Re: Comments by the New York State Department of Public Service on the Draft Environmental Impact Statement (DEIS) for Copenhagen Wind Farm in the Town of Denmark, Lewis County

APPENDIX A – DPS Staff Comments on DEIS for Copenhagen Wind Farm Project

Figure 2 – Soil Map Details

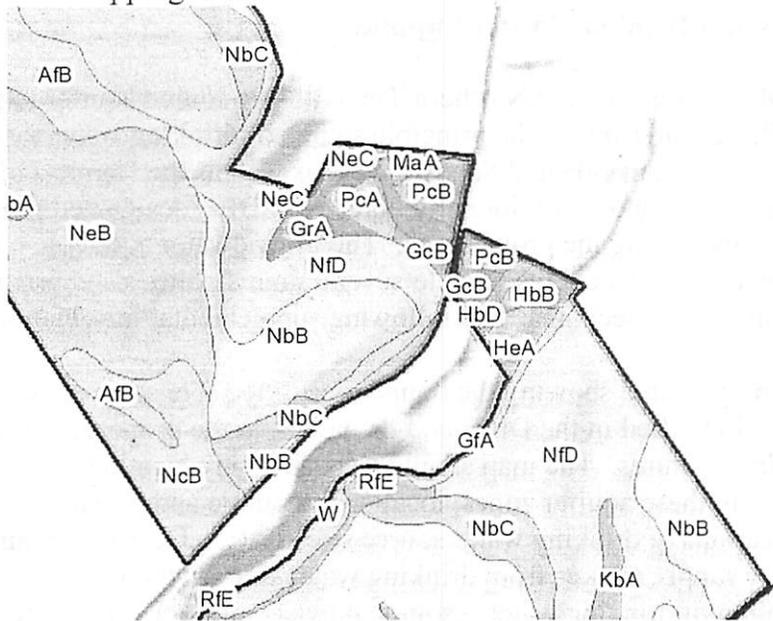
The electrical collection line(s) for the eastern half of the project line are apparently co-located at one crossing point of the Deer River east of the Deer River Road crossing. At this location, the lines will cross soils labeled as NfD (Rock Outcrop-Farmington Complex, 15 to 35 percent slope): and HbD (indicated as Herkimer Silt Loam, slopes from 15 to 25 percent). These are steep slope conditions adjoining the major water

resource in the area. The figure below is an excerpt from Figure 4, Sheet 3, showing the soils mapping in the area near the Deer River.

This location warrants additional analysis of soils conditions and limitations, and appropriate facility design and construction controls for minimizing environmental impacts to the Deer River and tributary. The DEIS identifies this reach of the Deer River as Class C (DEIS, section 3.2.1.1, page 57); however water quality standards are applicable and appropriate measures to minimize impacts should be developed. This location should be assessed for access needs, since the ECS lines are proposed to cross the Deer River and the adjacent tributary. If the ECS lines will cross the river underground, then evaluation of various construction methods including Horizontal Direction Drilling, conventional boring, and trenching should be provided. These methods may require additional workspace near the river banks, and may require significant clearing, grading and laydown areas for staging the construction activities. Consideration of off-ROW access to the easterly side of the river should be addressed in assessing potential impacts and mitigation needs. If the proposal is for an overhead crossing of the Deer River, than consideration of design and mitigation measures to minimize visual impact in this area near the scenic gorge north of Copenhagen Village should be developed to inform decision-making. An identification of the number of 34.5 kV circuits, and the number, size and type of structures to support aerial crossing should be provided. An assessment of alternative arrangements of overhead and underground facilities is appropriate for a supplemental analysis prior to issuance of the FEIS.

Detailed maps of the project site soil showing the collector line, turbine locations, staging area, point of interconnection, substation, met tower location etc should be submitted. The currently provided maps do not give enough information, and are not sufficient to relate project layout to soils resources and limiting factors that may influence design of facilities and appropriate mitigation measures.

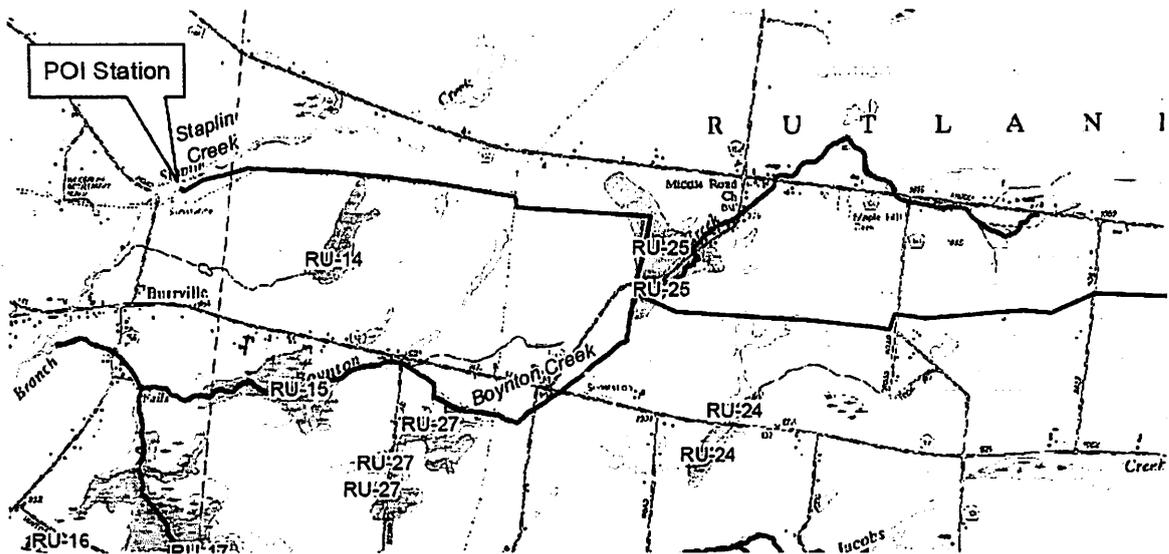
The 115 kV line makes a sharp angle turn at a location within NYS Regulated Wetland RU-25, south of Middle Road, as mapped at Figure 5B: Mapped Wetlands and Streams – Transmission Site. This area is indicated in the figure below, an excerpt from Figure 5B.

The angle in the transmission line indicated in this figure is acute and atypical of major transmission facilities, and the location of this excessive turn within a wetland area warrants additional design consideration. Angle turns on lines of this size require significant degrees of anchoring to provide necessary stability of the support structure to counter the tension on the structure from the electrical conductors. Typical anchoring involves structural support, such as either by multiple-pole structures with guy-wires and anchors embedded into firm ground; or steel pole(s) supported by concrete foundation(s). Either option at a wetland location as indicated at this site will require significant accessibility needs, for large equipment such as a concrete delivery vehicle, and wire-pulling rigs.
